Smallwood's Responses to P24G

19 July 2007

Fatalities found per
1000 turbine searches

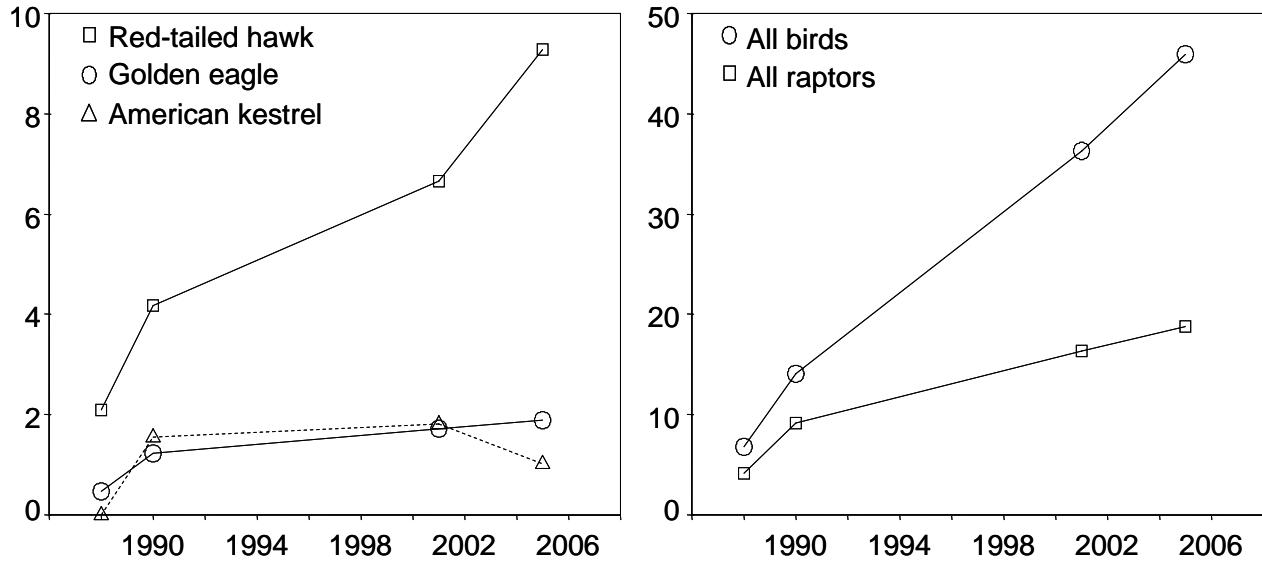
I recently compared fatality monitoring results from studies that sampled turbines from throughout the APWRA. In the figure below, the number of fatalities found per 1000 wind turbine searches are compared among 4 APWRA-wide studies: 1988-89 (Howell and DiDonato 1991), 1989-91 (Orloff and Flannery 1992; R30), 1998-2003 (Smallwood and Thelander 2004; R2), and 2005-06 (WEST, Inc. 2006; R36). Data were plotted on the middle year of each study. For raptors, turbines were assumed searched once per month in Howell and DiDonato (1991) and Orloff and Flannery (1992), even though actual searches occurred weekly and biweekly in those studies. Raptors typically last longer in the environment, so monthly searches would find nearly as many raptors as weekly or biweekly searches.

These graphs demonstrate no reduction in mortality, except perhaps for American kestrel. In fact, the graphs indicate a general increase in mortality. Reasons for the increase could be several: (1) researchers may have used different methods, though it is unclear whether methods differed enough to matter; (2) raptors might be accumulating in the APWRA as they are forced out of other habitat areas destroyed by human activities; and (3) changes in the APWRA might have increased collision risk, such as converting from lattice to tubular towers, commencing ground squirrel control in 1997, and deploying derelict lattice towers at ends of turbine rows after 2003.
